MILITARY SPECIFICATION

LOUDSPEAKERS, PERMANENT MAGNET, BLASTPROOF
AND SUBMERSIBLE, NAVY TYPE 4954o ()

This amendment forms a part of Military Specification MIL-L-16225B(SHIPS), dated 12 January 1961.

FIGURE 2. Orientation in acoustical tests.

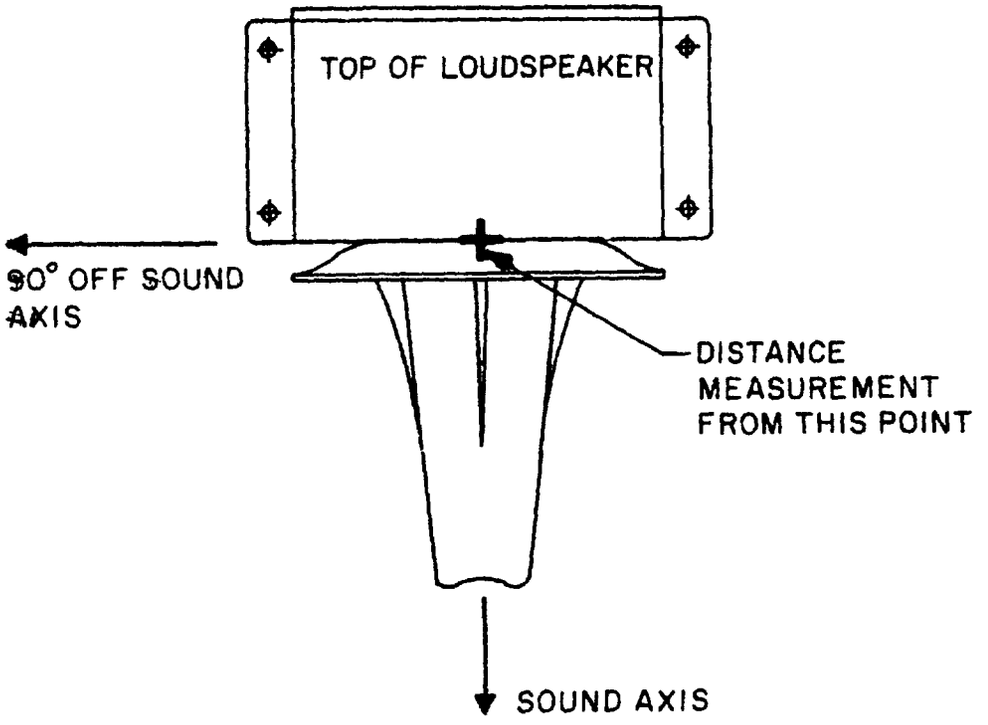
3.6.1, last sentence, delete and substitute: "The frequency response, when tested 90° off the sound axis (see figure 2) shall be within the limits shown in figure 1."

Following figure 1, add figure 2 as printed on page 2 of this amendment.
